ADDENDUM NO.: 4

DATE OF ADDENDUM: August 21, 2015

**CAMPUS RENOVATIONS
ASNUNTUCK COMMUNITY COLLEGE
170 ELM STREET
ENFIELD, CT
BI – CTC-437**

PARTIAL ROOF PLAN - SOUTH EAST
 1/8" = 1'-0"

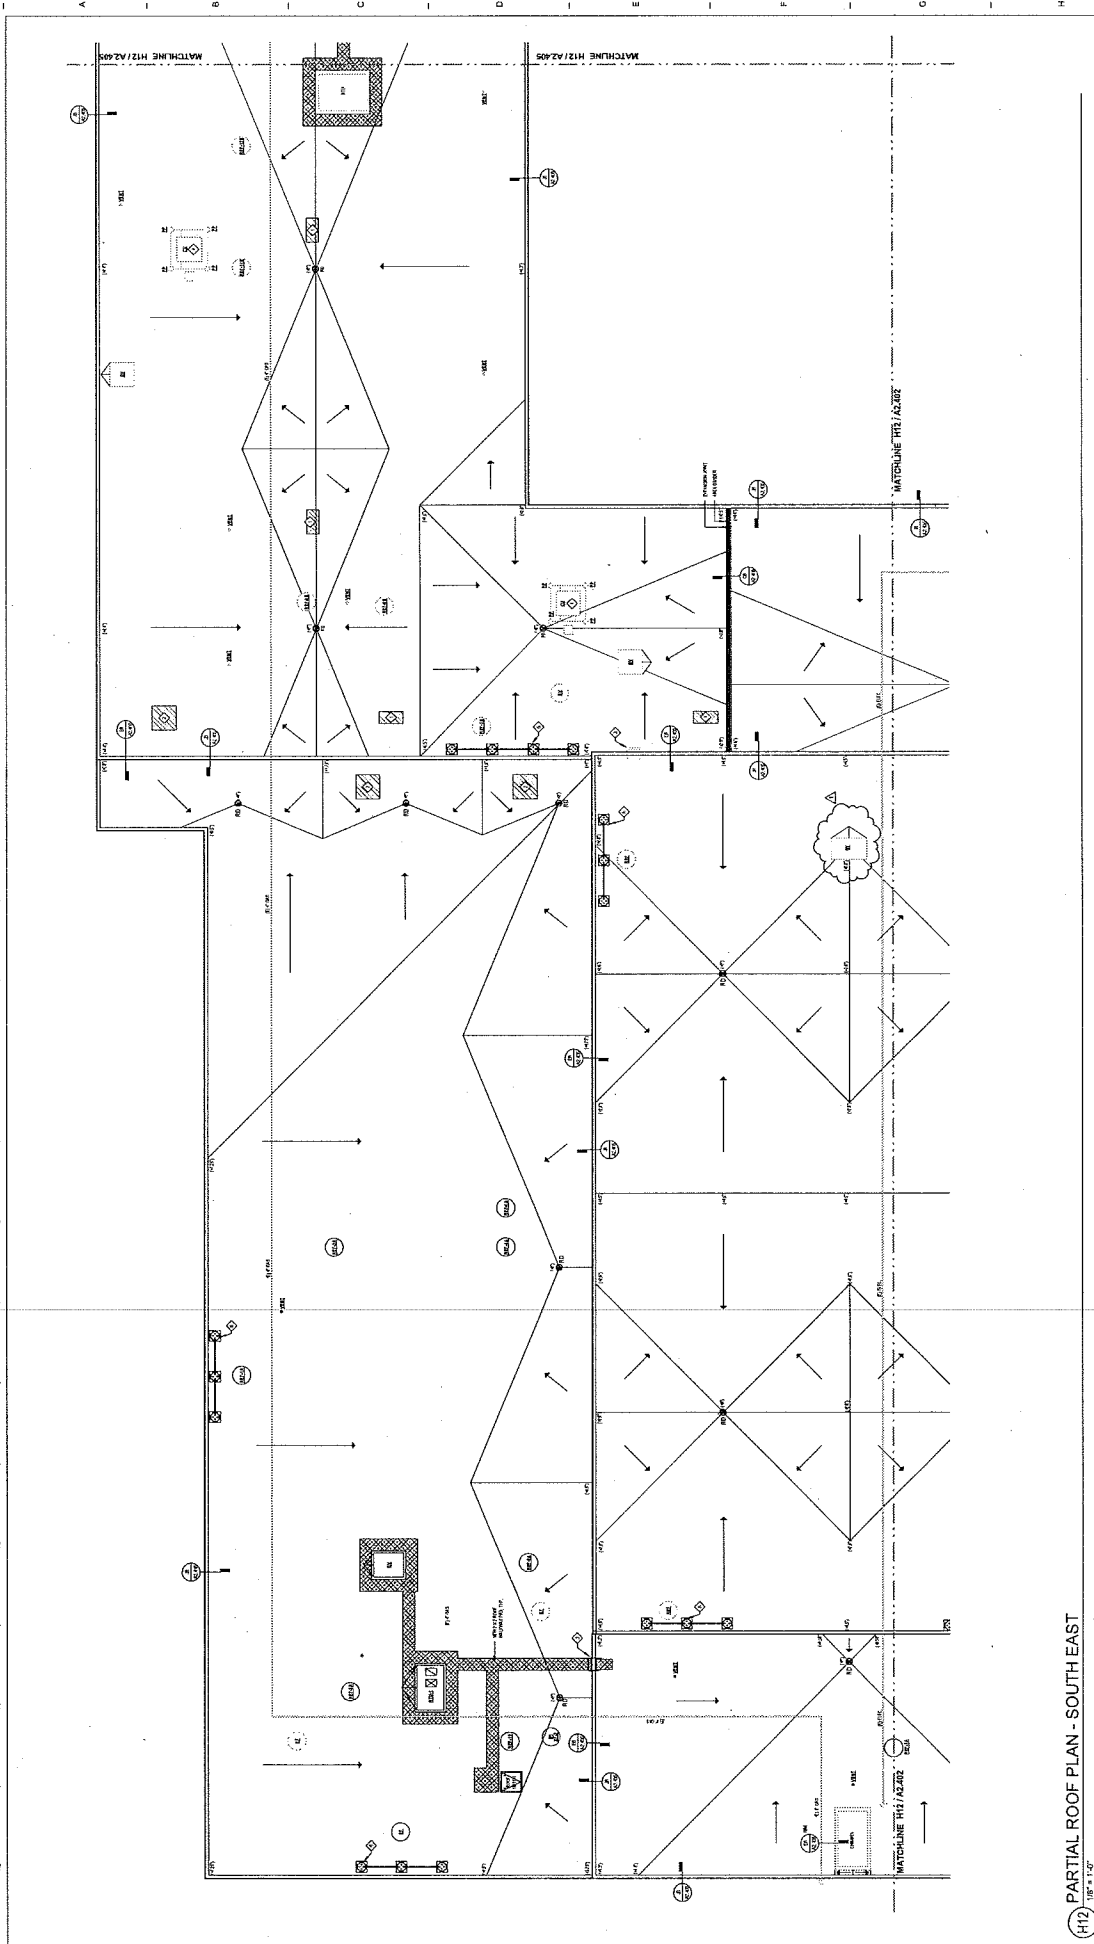
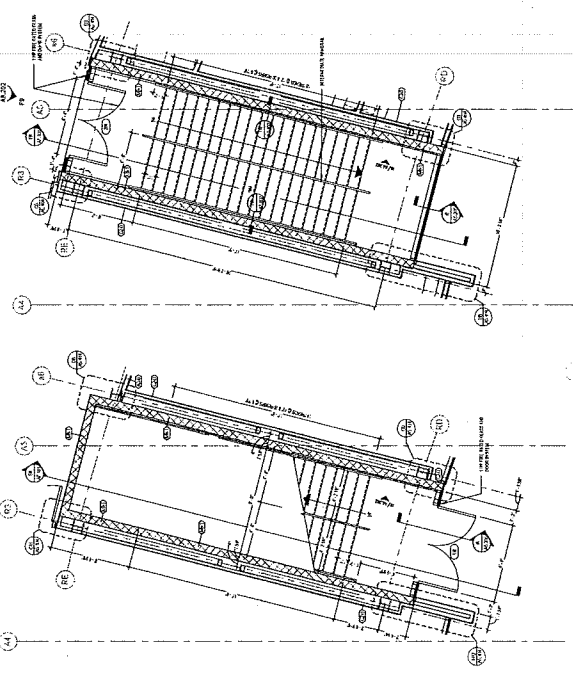
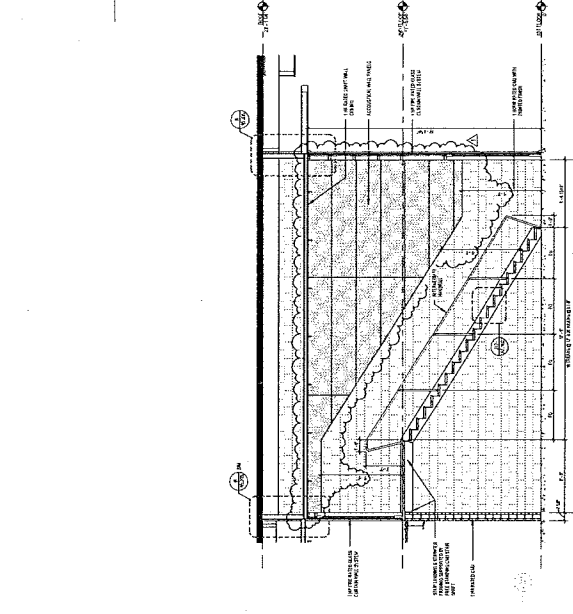
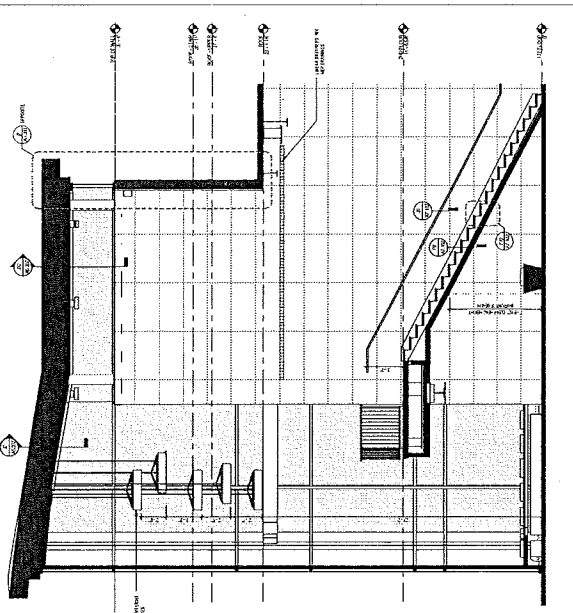
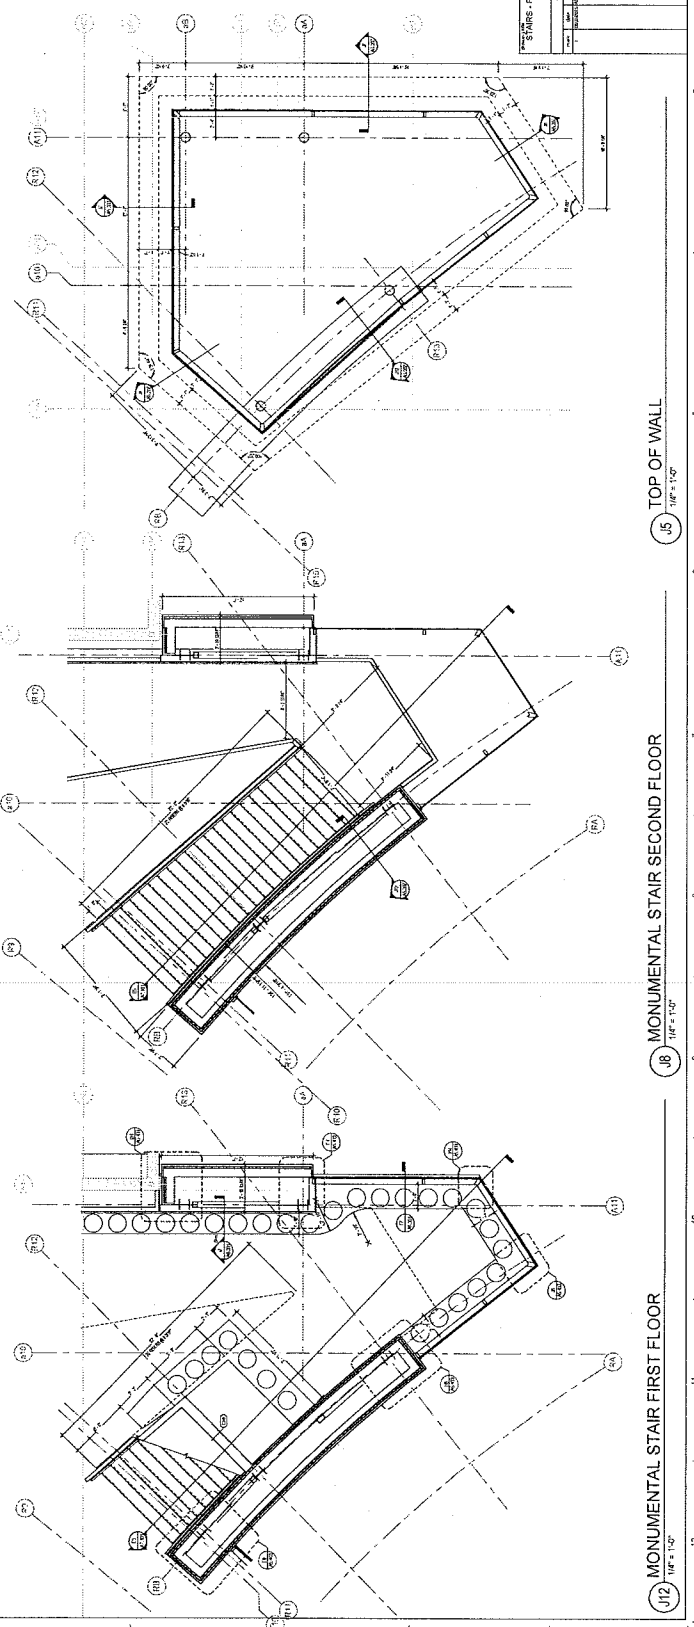
- **ADDED** Existing roof top equipment to gym roof

STAIRS - PLANS, SECTIONS

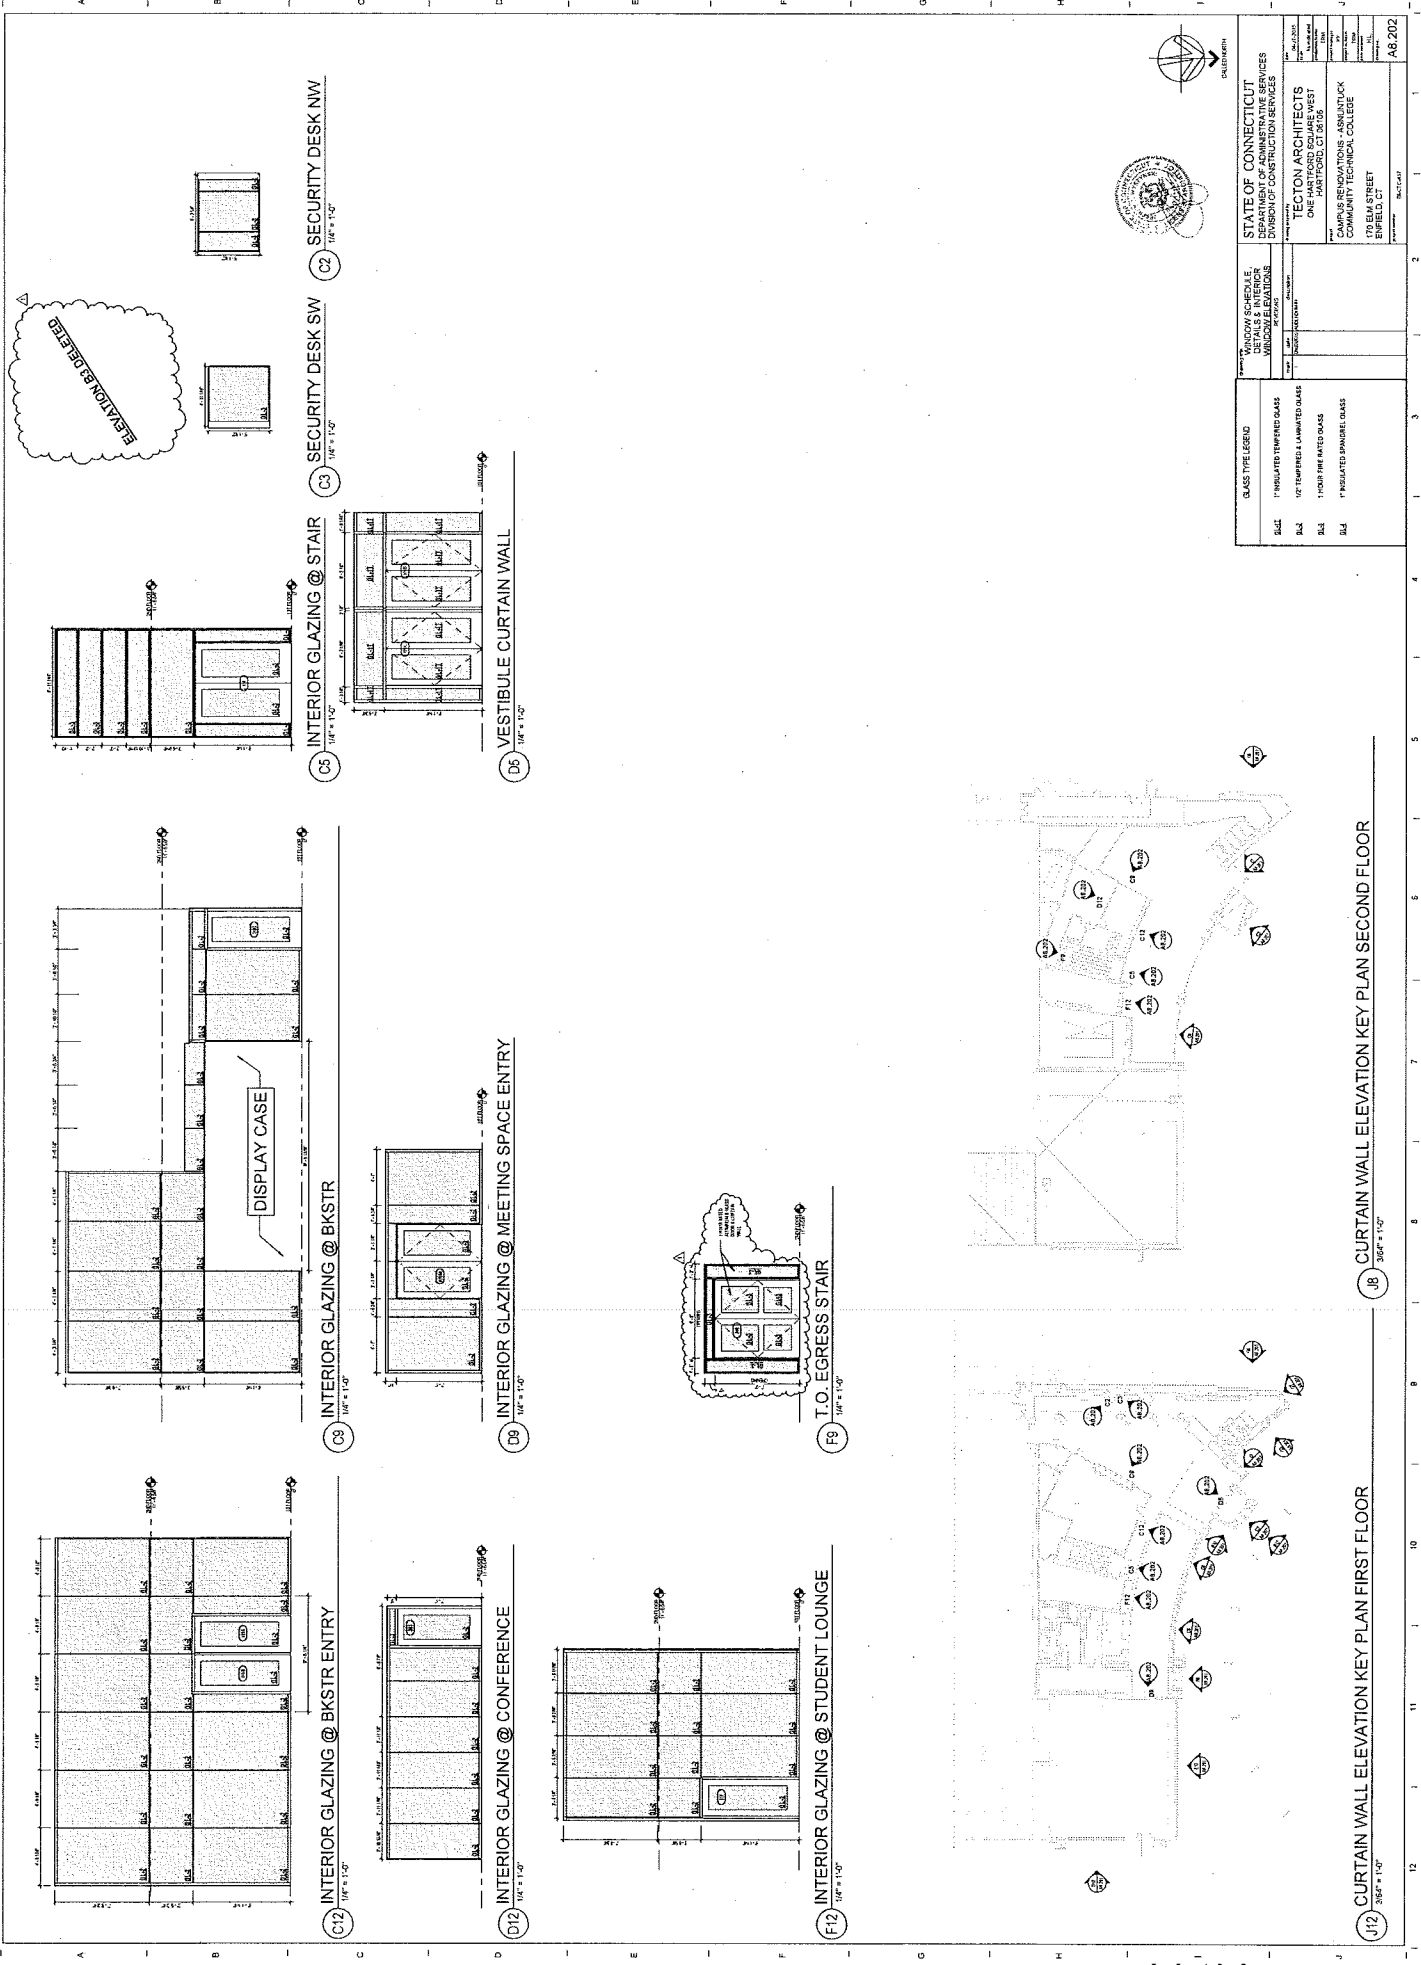
- REVISED acoustical wall panel layout and dimensions on section E8

Drawing A8.202 - Window Schedule, Details & Interior Window Elevations

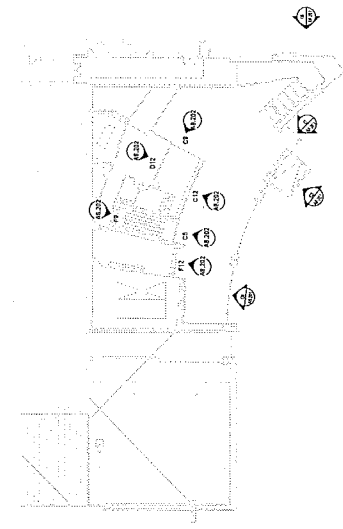
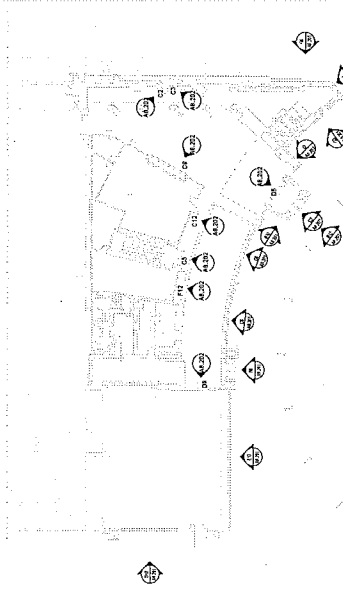
Question: Reference drawing A8.202 Opening types F9 and B3, and door schedule 08 06 10-1door numbers 206, & 207. Please clarify which opening should be fire rated, hollow metal or aluminum. Both doorways are marked 206 on the elevations I believe F9 is intended to be fire rated but B3 has fire rated glass noted. And confirm if B3 is to be Hollow Metal as noted on the door schedule.

- DELETED elevation B3
- REVISED elevation F9

Answer: The correct elevation for door #206 is elevation F9/A8.202. Elevation F9/A8.202 has been revised to show 1 hour fire rated glazing and elevation B3/A8.202 has been deleted from the project. As indicated in section 08 06 10 'Schedule of Openings', door #206 is a 1 hour fire rated aluminum and glass door with a 1 hour fire rated aluminum frame. Door #207 is a non-rated solid core wood door (SCW) with a non-rated hollow metal frame type HM-1.

Additionally, all aluminum doors, aluminum frames and aluminum entrance systems indicated to be of 1 hour fire rated construction on the drawings or in section 08 06 10 'Schedule of Openings' shall be constructed of a fire rated curtain wall system as specified in section 08 44 33 'Fire-Rated Glazed Curtain Walls'.

GENERAL ROOF MEET DEMOLITION PLAN
 MEP2.100 - 1/16" = 1'-0"

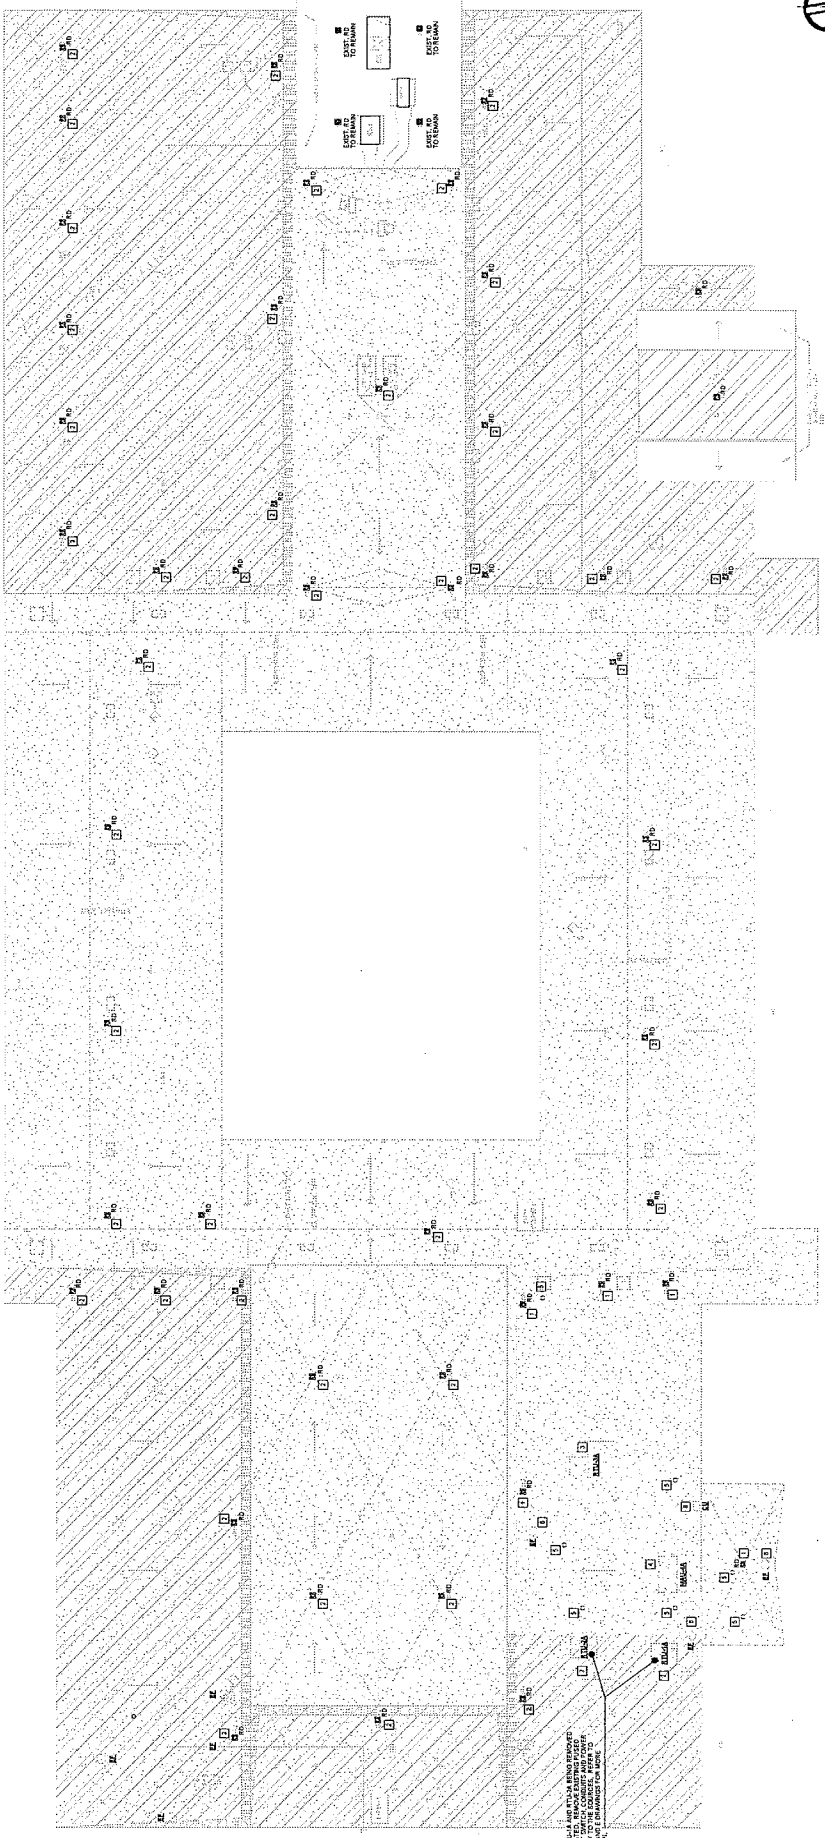
- REVISED Notes 3, 6 and 8.
